PEER REVIEW/CONCURRENT EVALUATION OF DPR AND BID PROCESS MANAGEMENT FOR THE MUMBAI COASTAL ROAD PROJECT

PHASE II & PHASE III REPORT

March 2016

Peer Review/ Concurrent Evaluation of Detailed Project Report and Bid Process Management for Mumbai Coastal Road Project

Figure 3-12 Section 6 - Alternative I

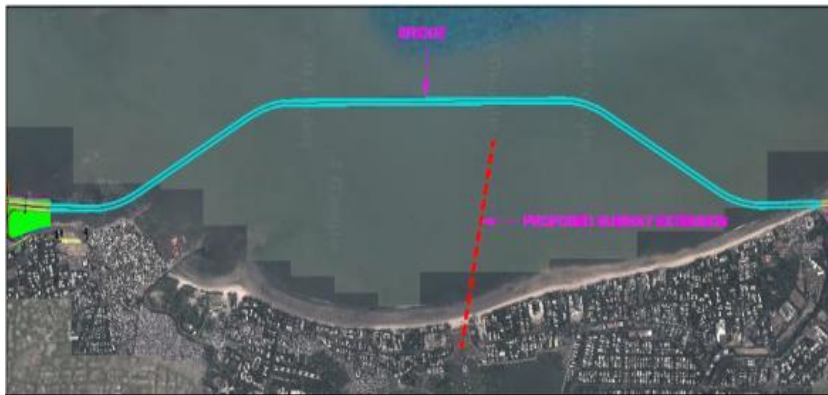
In this Alternative I the alignment of road remains same as that of DPR Option 5 and 6 with modification to overcome the constraint of expansion of Juhu runway as shown in Figure 3-12. Further it is suggested to explore the possibility of construction of bridge in place of tunnel. This is similar to the alignment previously studied by MSRDC as a sea link option. However the proposed alignment is comparatively closer to the shore than proposed by MSRDC. This proposed alignment is about 1.5 km from the shore line providing almost a 200m clearance to the end of proposed Juhu runway extension. This option will minimise the construction cost as compared to tunnel construction. Also, the difficulty of providing emergency exits and ventilation shafts in case of tunnel construction in option 5 & 6 can be overcome with the construction of bridge. This option will not disturb the existing beach. The bridge may be designed with the best aesthetics as in case of Bandra Worli Sea Link,

However, as noted above there is a proposal of extension of Juhu runway into the sea for a length of about 1 to 1.20 Km by Airport Authority of India (as shown in dotted red line in figure). Therefore, feasibility of this option depends on the clearance required within the takeoff or landing flight path. This is still a manageable option if clearances required from AAI are obtained for the bridge option.

Figure 3-23 Preferred Alignment - Option 7 (Section 1 and Section 6 to Section 7)

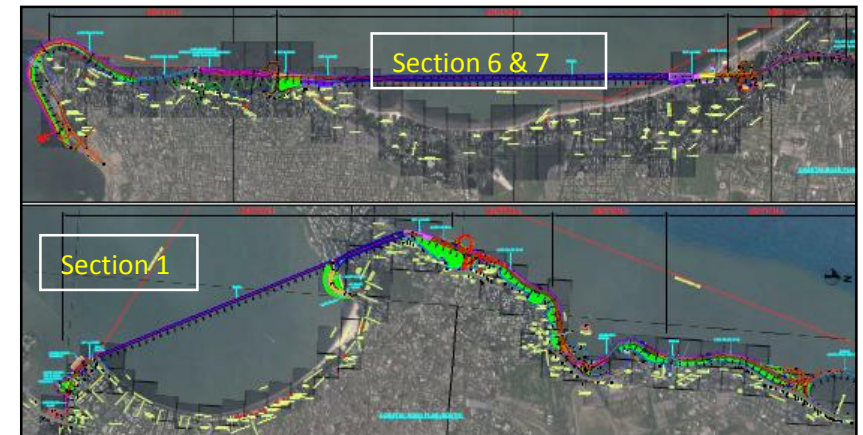
We have reviewed Typical Cross section drawings, Plan and Profile drawings as received from DPR Consultants under Volume VII: Drawings dated February 2015. It is noted that these drawings are developed for preferred Alignment Option, i.e. Option no. 7. This review is limited to Alignment in Phase II & III - Section 1 and Section 6 to 7, i.e. Jagannath Bhosale Marg to Priyadarshini Park, Khar Danda to Kandivali. In addition to the comments and observations made under conclusion and recommendation in of the each alignment above, following comments shall be taken into account for the preferred alignment.

Sr. No.	Report/ Drawing Reference	Element	Observation / Comments	Recommendation
1	8098/E/DD-407 (R1)	Typical Cross Section at Tunnel	Emergency lay by or cross passage is required in case of any emergency arising in tunnel	Provide emergency lay by or cross passage to other tunnel and include emergency exit / disaster management plan.
2	-	Road Capacity	Presently under phase II & III, four lane dual carriageway has been proposed by DPR Consultant	- As described in chapter 2, the minimum lane capacity for Phase II & III is as below, - Carter Road to Seven Bungalows (Versova) (Tunnel) – 4+4 lane - Seven Bungalows (Versova) to Madh Island Interchange(Elevated) – 4+4 lane - Madh Island Interchange to Kandivali Interchange - 4+4 Lanes (Elevated). The desirable is 5+5 lanes.
3	All drawings	SSD/DSD	SSD Visibility report and envelops considering all hazards as application to the design section, e. g. kerbs, safety barrier, parapets etc. to be developed to ensure correctness of geometry. Separate report on Decision sight Distance (DSD) to be developed for review for all Interchanges/ Toll Plaza and Change of cross section in accordance with IRC SP:99 Cl.2.9.3.2	Recommended for compliance.

Sr. No.	Report/ Drawing Reference	Element	Observation / Comments	Recommendation
4	All Profile Drawings	L Section (all)	Show the Sea Level (HTL or HRT) considered in design as minimum. The Proposed road level shall be in accordance with the requirement of shore protection and reclamation with due consideration to climate change. The present proposed level of +8.5m CD or +6.0m above MSL is likely to be on the lower side with respect to the design water level. The proposed structures like culverts, Bridges, Foot Over Bridges, and Interchange arms are not shown along profile. Show the crossing of Western Ferry Line in Profile.	The vertical alignment of the highway should ensure that there is sufficient construction depth to accommodate drainage infrastructure. Please indicate the details for better understanding, correctness, sufficiency and clarity. The design of storm water drainage, median drainage shall be taken in to account to decide on outfall connections into the existing / proposed structures. The storm water outfall shall be designed such as to avoid flooding of road during monsoon.

Figure 3-26 Alternative Layout at Tambe Chowk

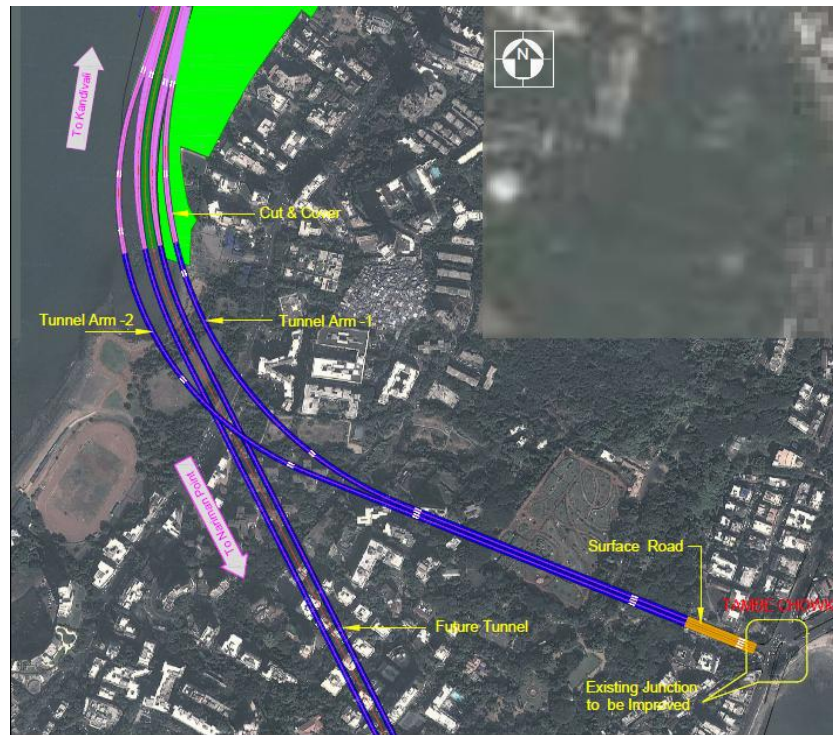
The proposed layout has been shown in Figure 3-26. The alignment is proposed to use the existing road named 1st Lane beside the Kilachand Garden which directly leads to the foothills of Malabar hill. Figure 3-27 & Figure 3-28 shows two options that can provide direct entry into the face of the hill by way of tunnel. This may require constructing an aerial cover as a safety / noise measure. This side would be difficult as TBM option but fine as a D&B or road header. Though, this will require acquisition of single or few buildings, this will facilitate direct entry to the tunnel by utilising the best usage of topography. The existing Junction will need some major improvements (reclamation towards sea side) to provide the proper access to the tunnel. Since this junction is prominently used by VVIPs a strategic planning and traffic management is the essence during execution. It is also anticipated that acquisition at this place may be major social issue inviting resistance from the people and public representatives. However, savings in terms of construction cost will be much higher than the cost that will be incurred for rehabilitation and resettlement.

Further, the facility can be augmented in near future by construction of undersea tunnel as originally planned in DPR.

Figure 3-29 Versova Interchange

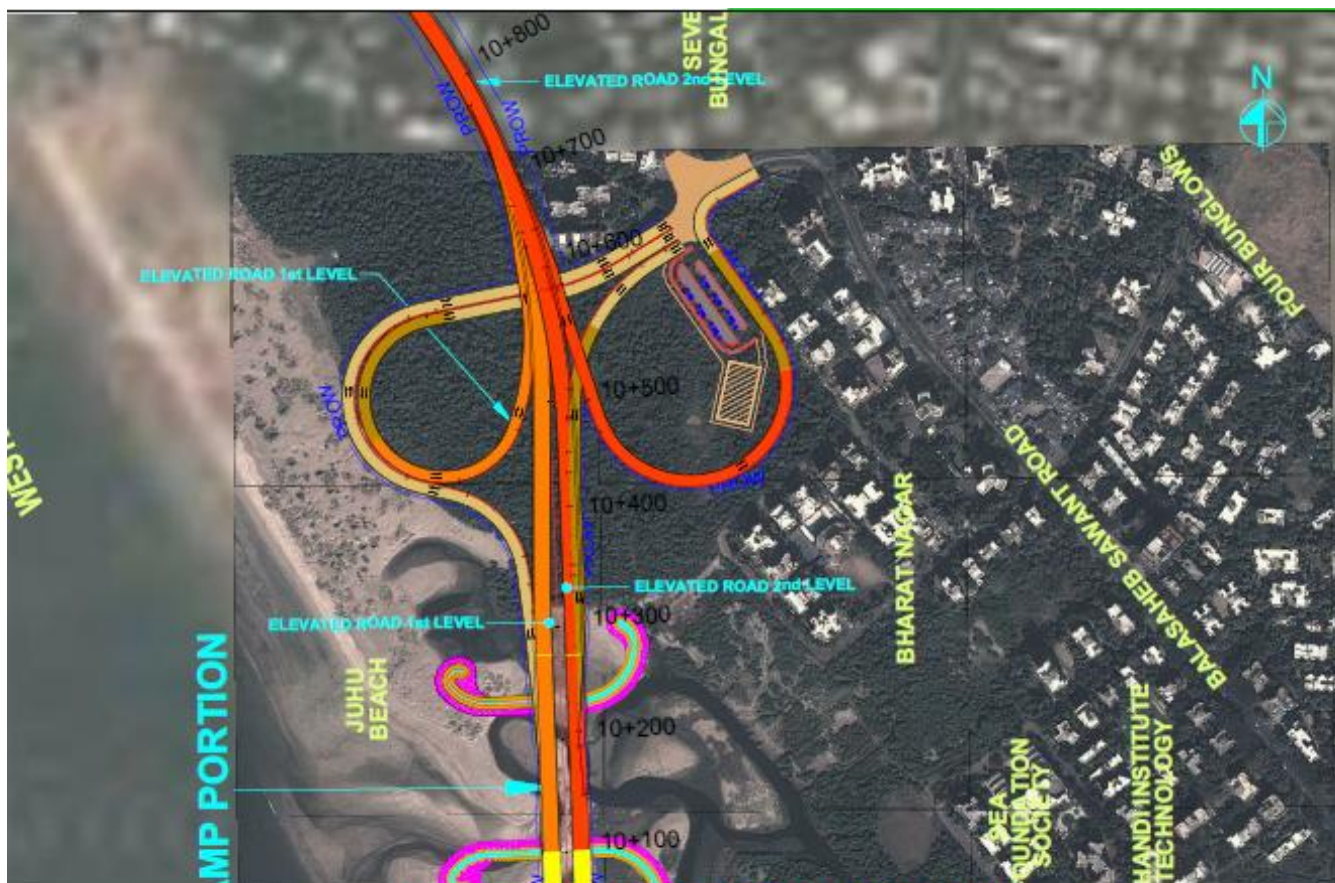
VERSOVA INTERCHANGE				
Sr. No.	Report / Drawing Reference	Element	Observation / Comments	Recommendation / Suggestion
1	8098/E/DD- 1161 (R0) to 1164,1163A and 1164A Note: 8098/E/DN-7	Location	The location of this interchange is in order in view of the traffic dispersal.	
2	8098/E/DD- 1161 (R0) to 1164,1163A and 1164A Note: 8098/E/DN-7	Traffic Dispersal	The provision has been made for traffic dispersal to and fro from Coastal road. The DPR report provides turning ADT.	Peak hour turning movement should be used to arrive at the requirement of different arms and their capacities at Interchange
3	8098/E/DD- 1161 (R0) to 1164,1163A and 1164A Note: 8098/E/DN-7	Design Speed	The Design speed adopted for interchange ramp and loop is 40 kmph which is not as per Table 3.1 of IRC SP 99.	The main road design speed is 80 kmph. The recommended design speed as given in table 3.1 of IRC SP 99 shall be followed. The geometry should be designed with respect to the design speed.

VERSOVA INTERCHANGE				
Sr. No.	Report / Drawing Reference	Element	Observation / Comments	Recommendation / Suggestion
5	8098/E/DD- 1161 (R0) to 1164,1163A and 1164A Note: 8098/E/DN-7	Tie-in with existing Road	It is not clear from layout if the interchange ramps are properly tie-in to existing Road. There appears to be a conflict of traffic entering coastal road and exiting coastal road at Seven Bungalows between Arm 4 and Arm 5. The Arm 5 provides exit from the coastal road to Seven Bungalows, however it is observed that the arm is merged on the wrong side of the existing road.	DPR consultant to clarify if sufficient space is available for tie-in. Provide 2-3 cross section at critical locations showing existing road and other feature or constraints. Conflict of Arm 4 and Arm 5 should be resolved. Road user safety and priorities shall be taken into account while improving this junction.
6	8098/E/DD- 1161 (R0) to 1164,1163A and 1164A Note: 8098/E/DN-7	All Tie-ins	Tie-in shall be matched properly. The tie-in shall be in same design plane as per main carriageway sufficiently covering the acceleration and deceleration lengths. Design contours shall be made available for further review.	DPR consultant to confirm.

7	8098/E/DD- 1161 (R0) to 1164,1163A and 1164A Note: 8098/E/DN-7	Visibility	Visibility report / envelopes not available for review. SSD and Decision sight distance (DSD) (as per table 2.7 and 2.8 of IRC SP 99) shall be available.	DPR consultant to provide visibility report and confirm availability of SSD/DSD considering all the hazards e. g. kerb, parapets etc. Widening shall be incorporated wherever necessary or appropriate mitigation measures shall be suggested and incorporated in design.

VERSOVA INTERCHANGE				
Sr. No.	Report / Drawing Reference	Element	Observation / Comments	Recommendation / Suggestion
8	8098/E/DD- 1161 (R0) to 1164,1163A and 1164A Note: 8098/E/DN-7	Turning movement	Width of loops and ramps on curves needs to be checked for manoeuvring of large vehicles.	DPR consultant shall confirm conflict free manoeuvring based on Auto Turn layout considering the highest possible rigid vehicle length likely to use the interchange. Deficient bends shall be widened appropriately.
9	8098/E/DD- 1161 (R0) to 1164,1163A and 1164A Note: 8098/E/DN-7	Crossfall/ Superelevation	The location of tie-in and application of super elevation are likely to cause flat spot issues which are undesirable as they have potential to cause accidents.	Flat spot shall be avoided. DPR consultant shall provide flat spot report and confirm there are no flat spot when checked for desirable gradient of 0.5%.

Figure 3-31 Oshiwara Interchange

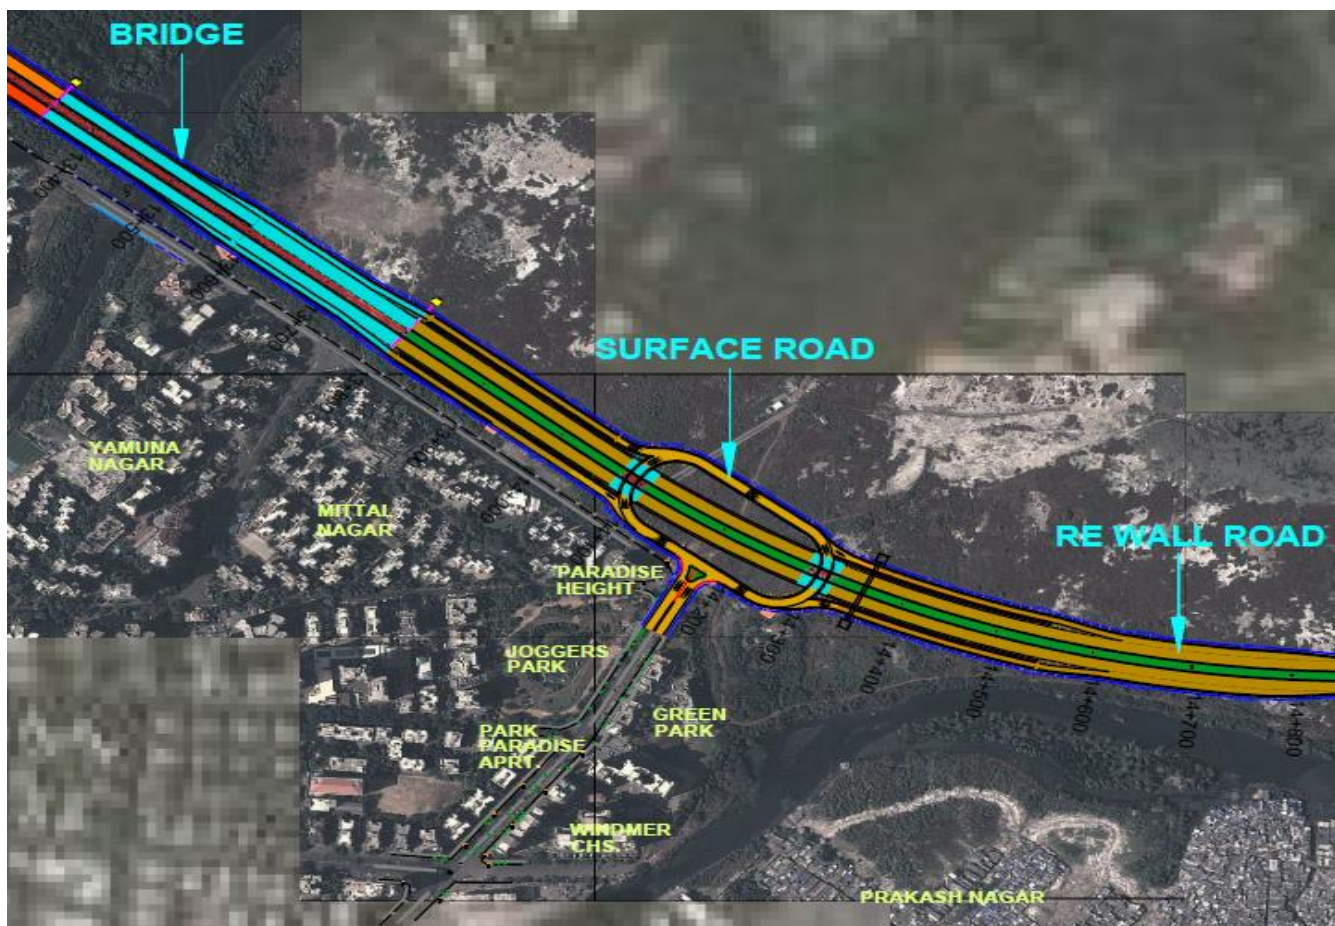
OSHIWARA INTERCHANGE				
Sr. No.	Report / Drawing Reference	Element	Observation / Comments	Recommendation / Suggestion
1	8098/E/DD- 1220 (R0) to 1226 and 8098/E/DD -1220A(R0) to 1226A Note: 8098/E/DN-7	Location	The location of this interchange is in order in view of the traffic dispersal.	
2	8098/E/DD- 1220 (R0) to 1226 and 8098/E/DD -1220A(R0) to 1226A Note: 8098/E/DN-7 Note: 8098/E/DN-7	Traffic Dispersal	The provision has been made for traffic dispersal to and fro from Coastal road. The DPR report provides turning ADT.	Peak hour turning movement should be used to arrive at the requirement of different arms and their capacities at Interchange.
3	8098/E/DD- 1220 (R0) to 1226 and 8098/E/DD -1220A(R0) to 1226A Note: 8098/E/DN-7	Design Speed	The Design speed adopted for interchange ramp and loop is 40 kmph which is not as per Table 3.1 of IRC SP 99.	The main road design speed is 80 kmph. The recommended design speed as given in table 3.1 of IRC SP 99 shall be followed. The geometry should be designed with respect to the design speed.

OSHIWARA INTERCHANGE				
Sr. No.	Report / Drawing Reference	Element	Observation / Comments	Recommendation / Suggestion
5	8098/E/DD- 1220 (R0) to 1226 and 8098/E/DD -1220A(R0) to 1226A Note: 8098/E/DN-7	Tie-in with existing Road	It is not clear from layout if the interchange ramps are properly tie-in to existing Road.	DPR consultant to clarify if sufficient space is available for tie-in. Provide 2-3 cross section at critical locations showing existing road and other feature or constraints.
6	8098/E/DD- 1220 (R0) to 1226 and 8098/E/DD -1220A(R0) to 1226A Note: 8098/E/DN-7	All Tie-ins	Tie-in shall be matched properly. The tie-in shall be in same design plane as per main carriageway sufficiently covering the acceleration and deceleration lengths. Design contours shall be made available for further review.	DPR consultant to confirm.
7	8098/E/DD- 1220 (R0) to 1226 and 8098/E/DD -1220A(R0) to 1226A Note: 8098/E/DN-7	Visibility	Visibility report / envelopes not available for review. SSD and Decision sight distance (DSD) (as per table 2.7 and 2.8 of IRC SP 99) shall be available.	DPR consultant to provide visibility report and confirm availability of SSD/DSD considering all the hazards e. G. kerb, parapets etc. Widening shall be incorporated wherever necessary or appropriate mitigation measures shall be suggested and incorporated in design.

OSHIWARA INTERCHANGE				
Sr. No.	Report / Drawing Reference	Element	Observation / Comments	Recommendation / Suggestion
9	8098/E/DD- 1220 (R0) to 1226 and 8098/E/DD -1220A(R0) to 1226A Note: 8098/E/DN-7	Crossfall / Superelevation	The location of tie-in and application of super elevation are likely to cause flat spot issues which are undesirable as they have potential to cause accidents.	Flat spot shall be avoided. DPR consultant shall provide flat spot report and confirm there are no flat spot when checked for desirable gradient of 0.5%.
10	8089/E/DD-008 R4	FOB / Metro / HT Line Conflict	Foot over bridge is proposed at this Interchange. The present proposal envisage coastal road to pass at first level while the roundabout arms are proposed at surface level. At site it is observed that HT line is passing in this area. It is also learnt that the Pahadi Goregaon area is also identified for proposed Metro Depot and Metro Line is suppose to pass over the coastal road to access depot.	As coastal road is planned at level 1, the proposed FOB will have to be over the coastal road at level 2. It is highly unlikely that public will use this FOB to cross over due to its height. Relocation of this FOB or a subway arrangement, lift, escalators or ramps shall be looked at. Also in view of the Metro Depot and Metro line passing over coastal road, the vertical profile of metro should be designed in accordance with the vertical profile of coastal road to ensure requisite vertical clearance. This needs to be communicated to Metro authority for necessary action.

Figure 3-35 Proposed Arrangement at Kandivali Interchange on Link Road

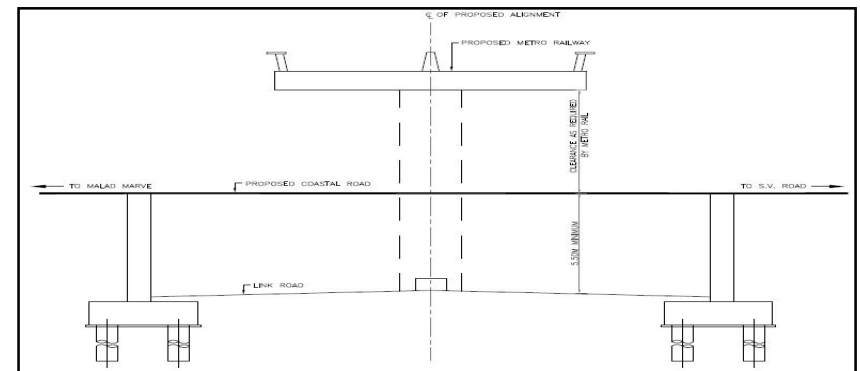
The Alternative- I is almost similar to what has been proposed by DPR consultant in drawing no. 8098/E/DD-008 R4 with minor change in traffic dispersal. Based on the fresh traffic survey and analysis a minimum of 4+4 lanes are required with desirable provision of 5+5. Considering minimum 4+4 lane requirement the Interchange layout is proposed. The exit has been proposed at two locations – the first one at the Link Road and the second one on to planned DP 2034 road with onward connection to Shankar Lane and S V Road. At present, encroachments are observed at this location which needs to be removed in view of DP 2034. Accordingly a two lane exit onto Link road and two lane exit connecting to Shankar Lane is proposed. The coastal road alignment is proposed to cross the Link Road at level 1. It is also acknowledged that Metro Line is planned on to Link road. Figure 3-35 represents the proposed cross section showing the

It is also learnt that the land on north-west of coastal road is identified as proposed Metro Depot. However, there doesn't appear to be any conflict with metro if requisite clearances are maintained and co-ordinated. The entry on to Link Road is planned at surface and therefore the entry of Metro to depot is conflict free. The only hurdle at this stage is removal of encroachment on the north-eastern side of the Link road.

The entry onto coastal road is planned from three points, first one as two lane entry from Shankar Lane, second one as two lane entry from Link road and third one as two lane entry from Malad Marve Marg through flyover. The flyover entry from Malad Marve Marg will eliminate the local conflict between coastal road user and access road to Ryan International School. The access road will pass beneath the flyover by maintaining necessary vertical clearance.

Figure 4-4 Malad Creek - Location

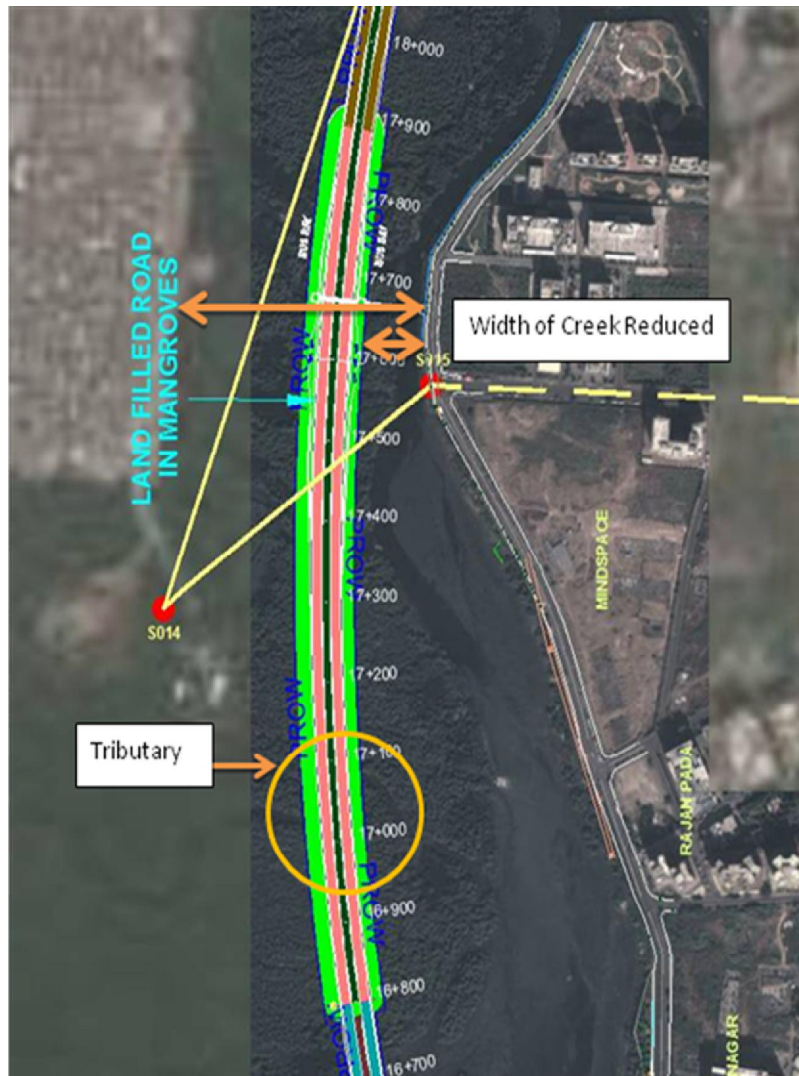
Main Report (February 2015) contains no information on the influence of urban run-off and fluvial flows on the design of the works. Figure 4-4 has been extracted from Drawing 8098/E/DD-008 (R5) and this shows that width of the floodplain at the upstream end of the creek will be significantly reduced by the proposals. The presence of the embankment will reduce the capacity of the channel to convey fluvial flood water and this will increase water levels upstream during extreme events. This could lead to flooding of adjacent properties. This eventuality has not been considered in the DPR.

It is considered that a hydrological analysis in conjunction with hydraulic modelling would have provided design criteria (peak water levels, peak current velocities) for the design of land filled roads embankments, bridges and other structures within the creek. It would have also facilitated the assessment of scour (at abutments) and flooding. Aerial photography also indicates that the land filled road will cross a number of small tidal tributaries / creeks as highlighted in Figure 4-4. It is assumed that these smaller creeks will be culverted under the road.
